Docket Item # 5  
BAR CASE # 2017-00344

BAR Meeting  
November 15, 2017

**ISSUE:** Demolition (serpentine wall)

**LOCATION:** 1101 North Washington Street

EXISTING SERPENTINE  
WALL TO BE  
DEMOLISHED ———

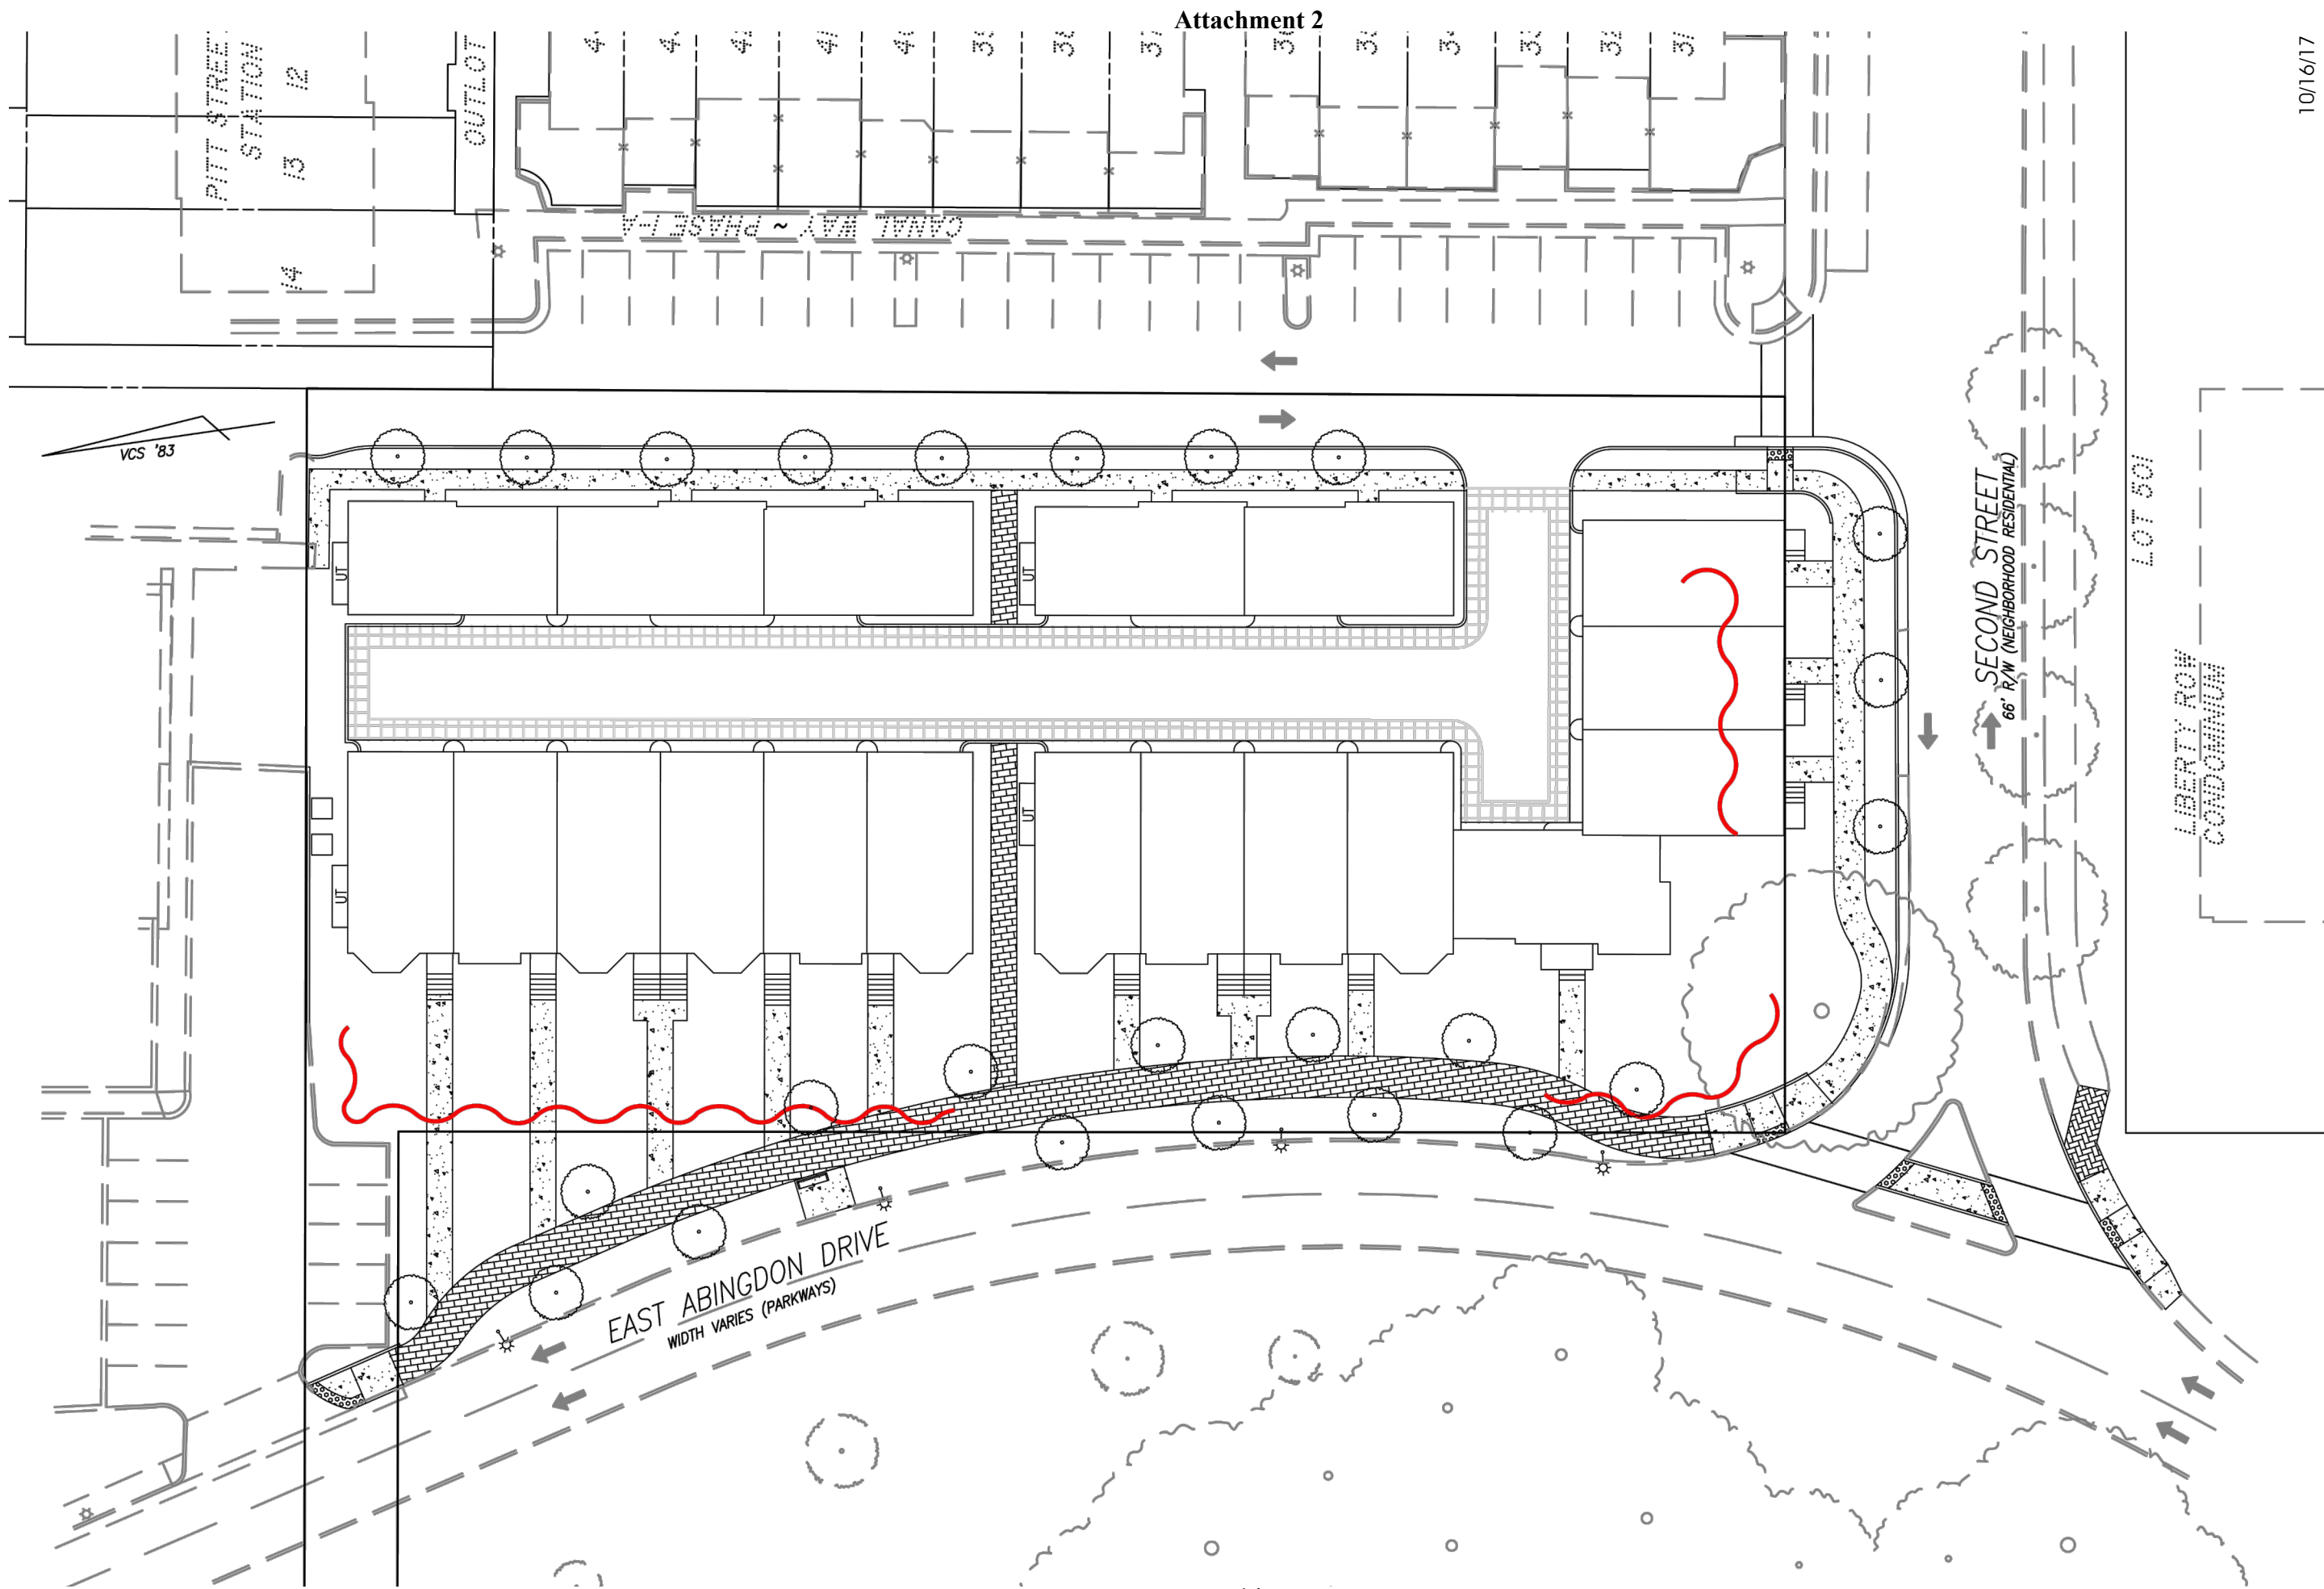
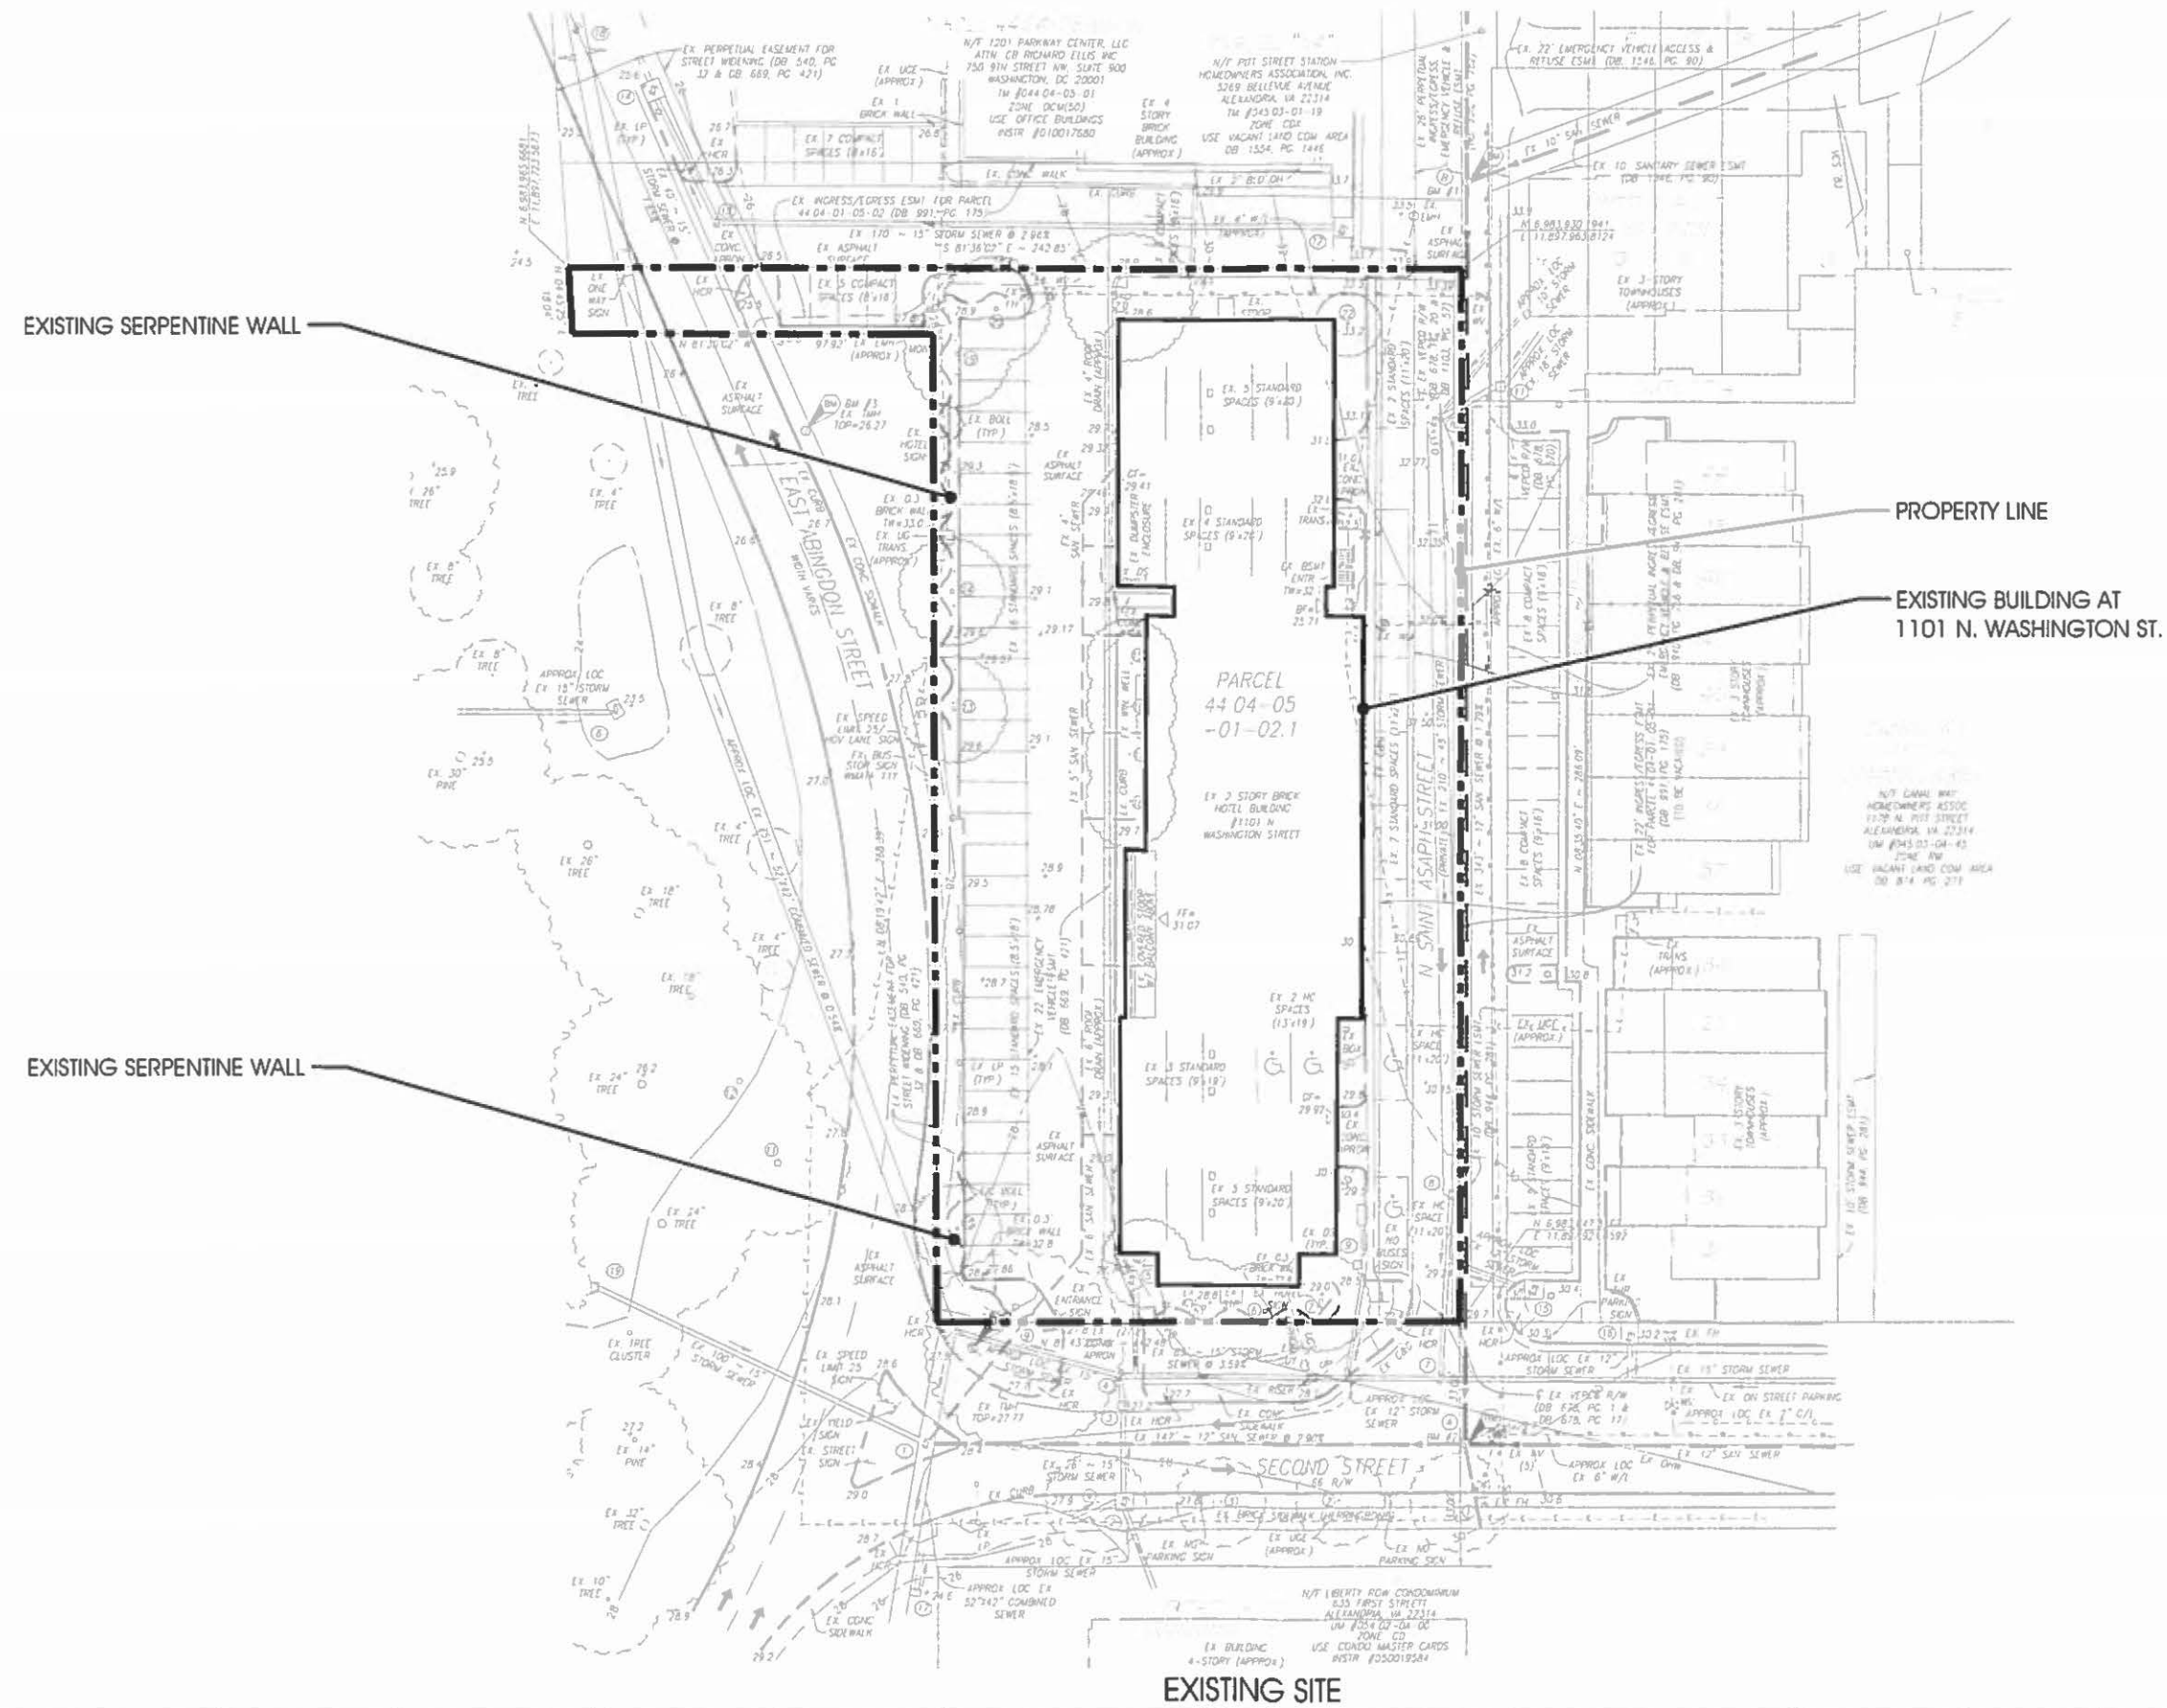
The applicant has provided an exhibit showing the location of the serpentine wall and illustrating that portions of the wall are in the location of the proposed townhouses or sidewalk. Therefore, *if* a portion of the wall were to be retained, it would be a small portion at the northwestern portion of the property and it would bear no relationship to its previous design intent or the new design program proposed for the site.

As requested at the October 4, 2017 BAR meeting, the Applicant has prepared an exhibit to show the conflicts between the existing wall and the proposed development to determine whether it is feasible to retain the serpentine wall. As discussed at the hearing, and as reflected on the attached Serpentine Wall Overlay Exhibit, the serpentine wall conflicts with the proposed streetscape, which is in keeping with the Old Town North Small Area Plan, and the proposed building layout, which establishes an urban frontage along Second Street. The Applicant still maintains that the wall, which was built in the 1960's, is not historic or architecturally significant, and should be demolished. However, to the extent that the BAR determines it is worthy of preservation, please see the Serpentine Wall exhibit which reflects revisions that could be made to the plan without running afoul of the streetscape and urban design guidelines while maintaining a portion of the wall.
